TYPICAL SECTION 1 - SR 14
SLM 25.41 - 26.59 & SLM 26.62 - 28.77
NOTE: SEE TYPICAL SECTION 7 ON P.5 FOR SLM 26.59 - 26.62
EXISTING: 12" ASPHALT OVER 8" CONCRETE

P.6

GENERAL SUMMARY

PAVEMENT CALCULATIONS

PAVEMENT WIDENING FOR ODNR PARKING AREA (TYPICAL SECTION 6)
SLM 26.59/STA. 01+48.04 TO SLM 26.62/STA. 03+39.96
11" ASPHALT OVER 10" CONCRETE

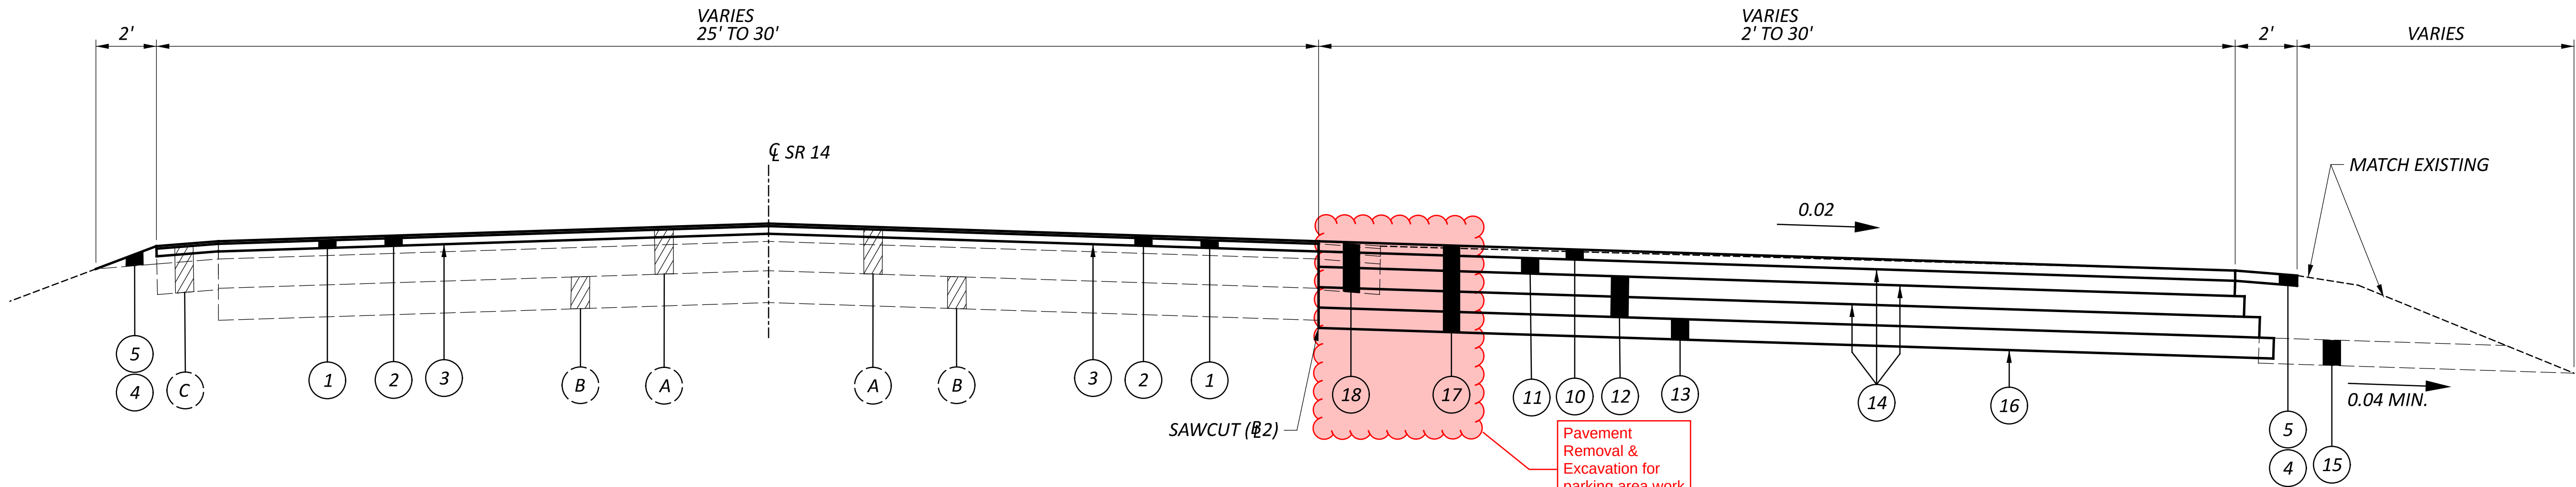
Items
Added

ROUTE	RESURFACING ONLY			
	SLM		AVG PW (RESURFACING)	LENGTH
	FROM	TO	(FEET)	(MILES)
SR 14	26.59	26.62	28	0.03
